FA466126Q0031 – MUNS Vindicator

Questions and Answers

Water Main Layout

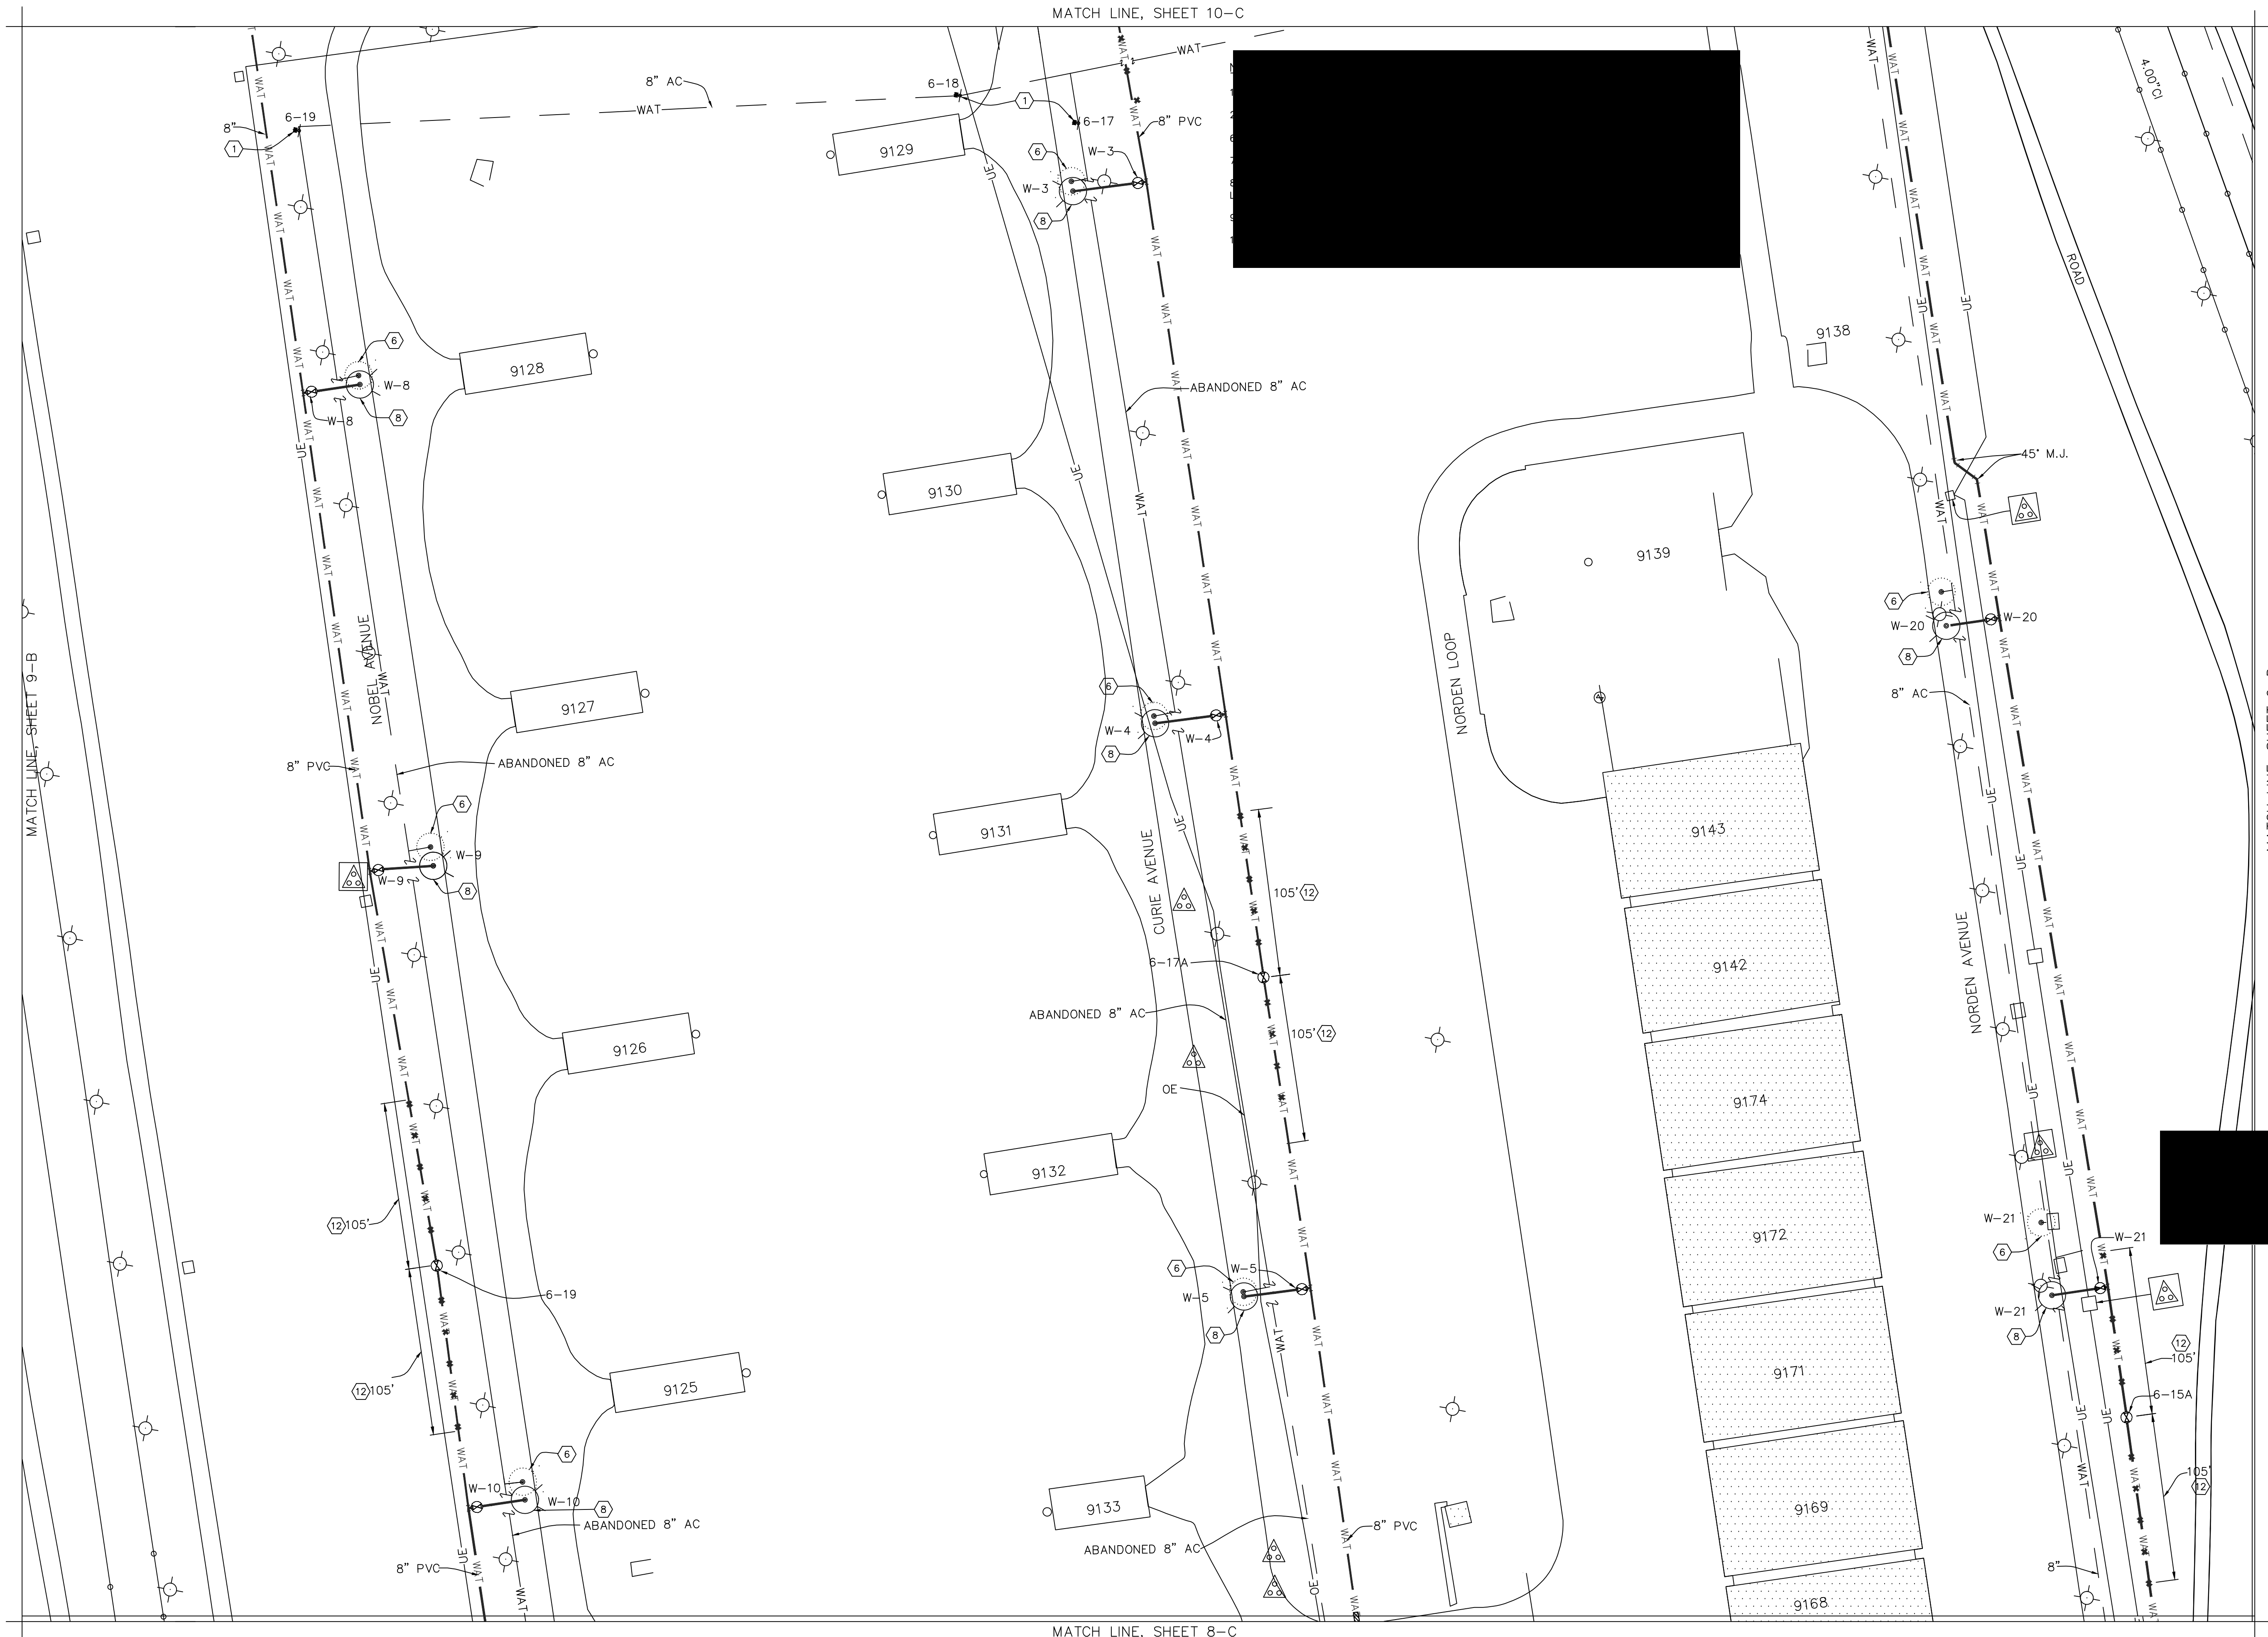
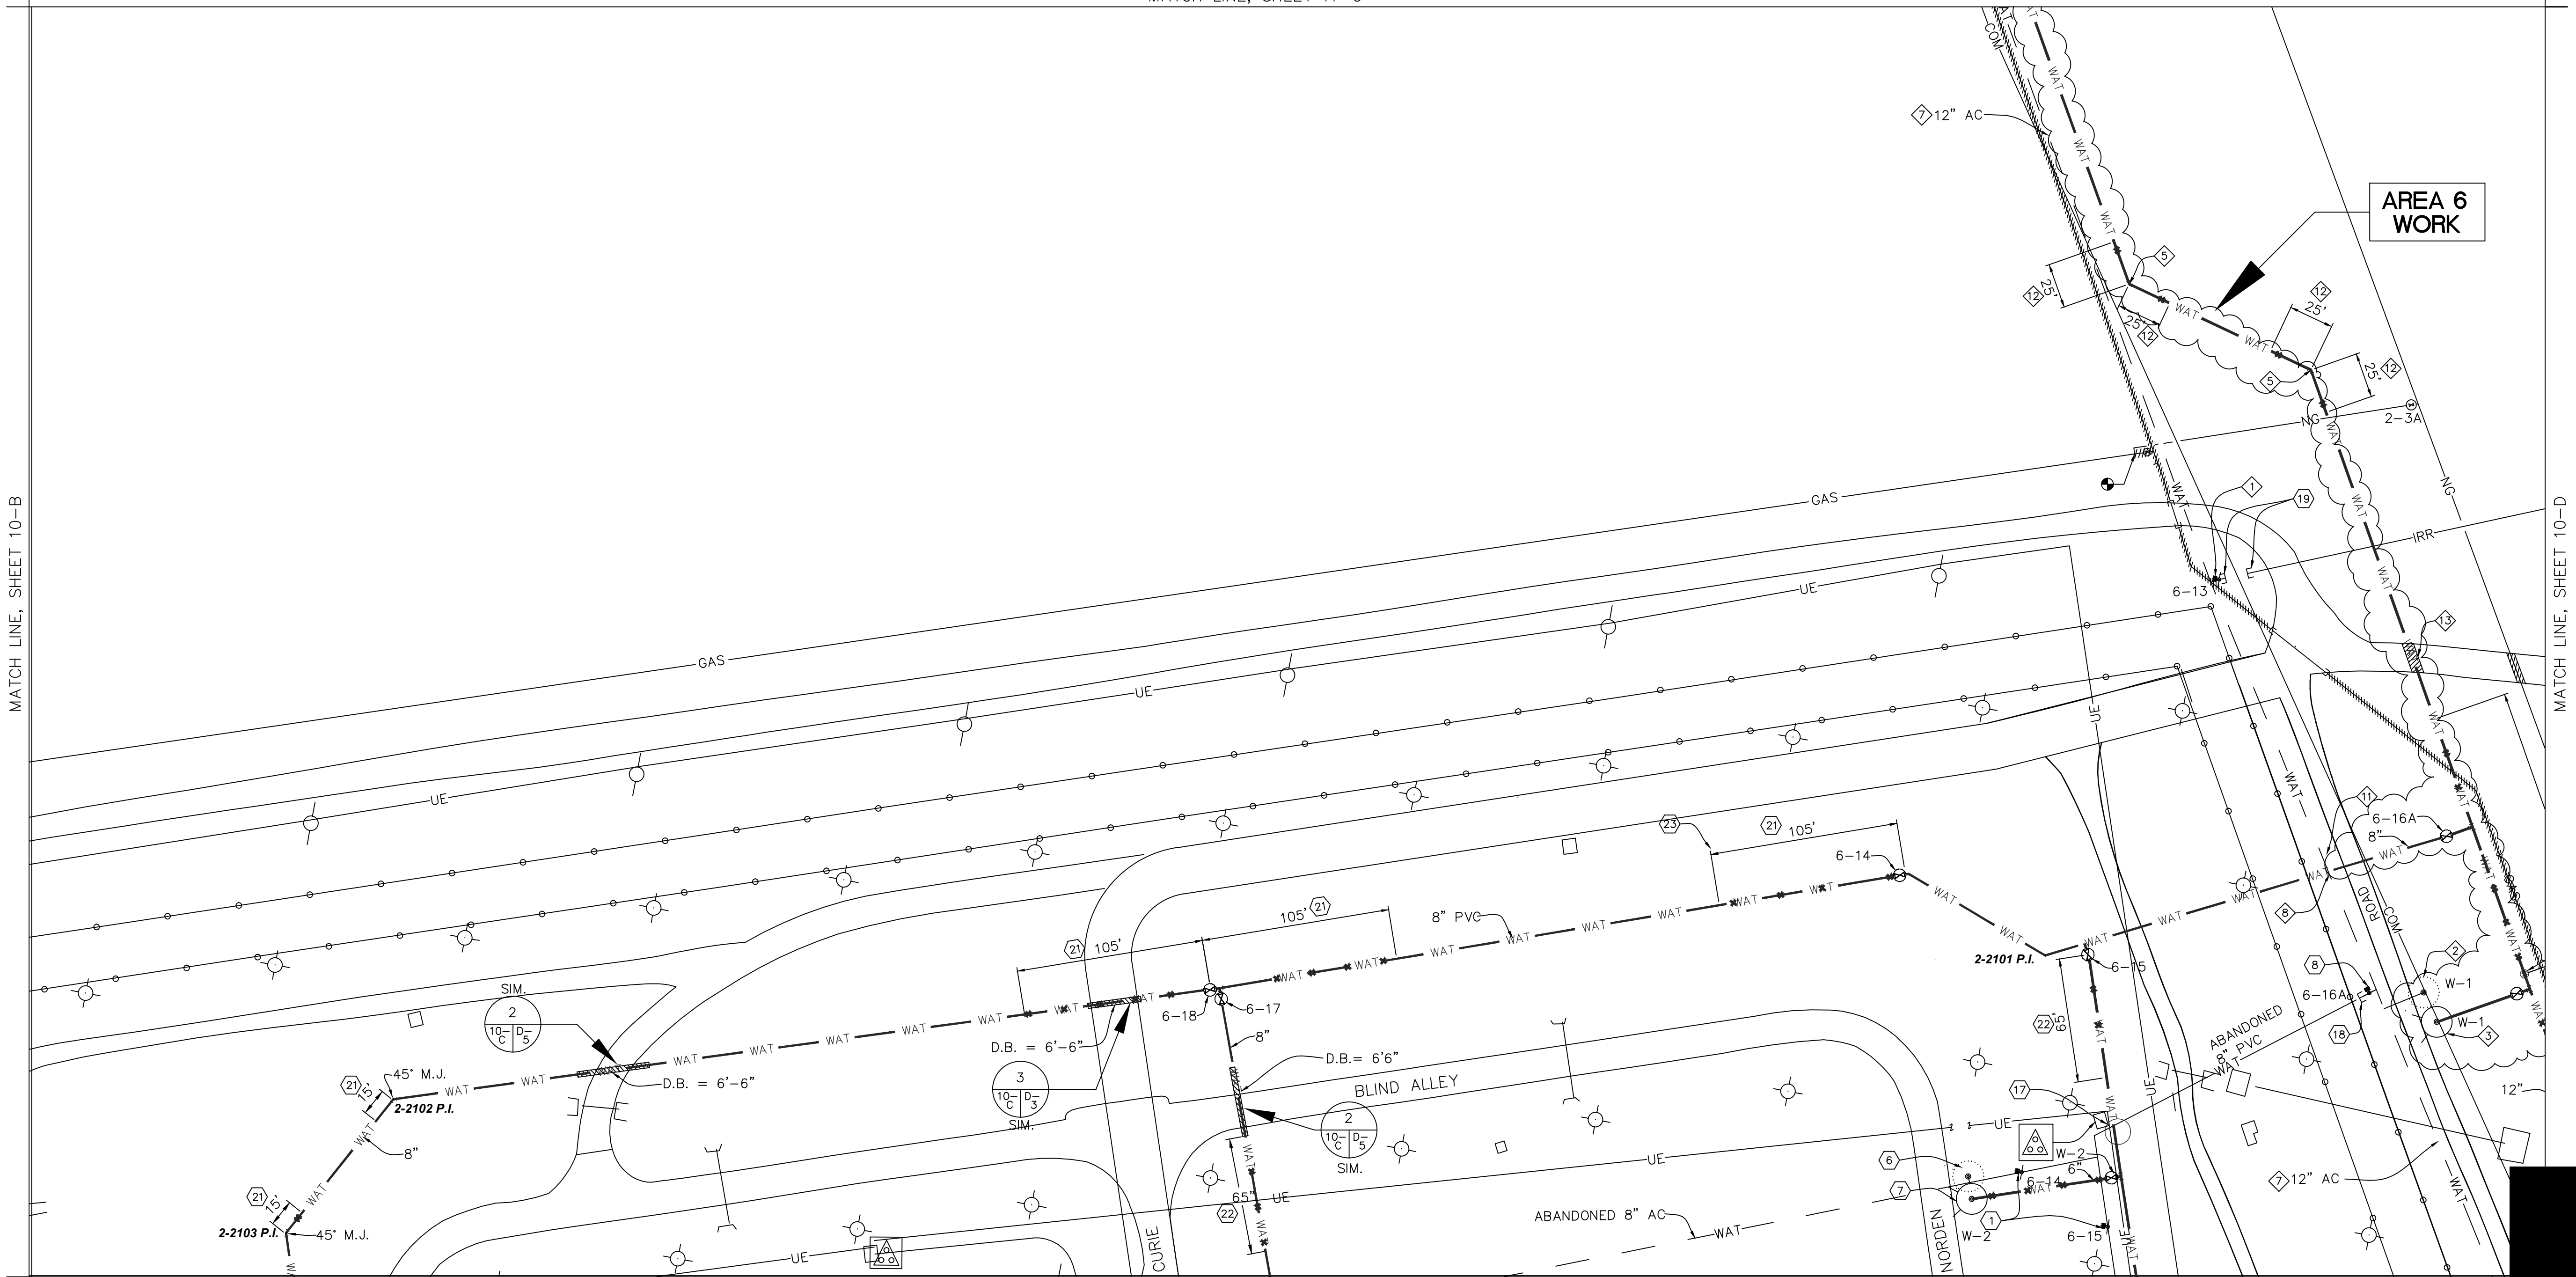
3. Can a map of gas lines be provided?	No gas line within the work area per site plan provided. Water main line shown in attached drawings. <u>Attachment 3</u> – Water Main Layout

Utility Trench Pavement Repair Section

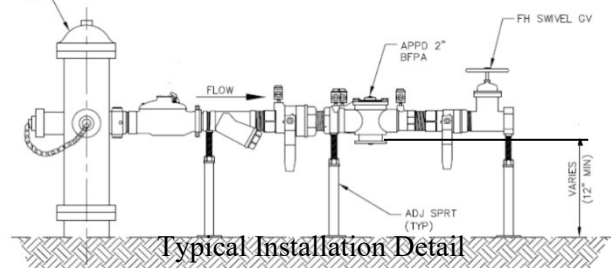
2. For the new conduit, are the existing roadways to be crossed concrete or asphalt?	Existing roadways to be crossed are asphalt. Refer to attached asphalt pavement, utility trench repairing section.

5. What are the specific requirements for compaction testing on this project?	Trench backfill should be compacted to 85% standard proctor (ASTM D698) for trenching in soil. 95% modified proctor (ASTM 1557) for trenching in pavement. <u>Attachment 5</u> – Utility Trench Pavement Repair Section
---	---

- SUBSTITUTE FLOWABLE FILL
WITH BACKFILL COMPACTED
TO 95% MODIFIED PROCTOR
(ASTM 1557)
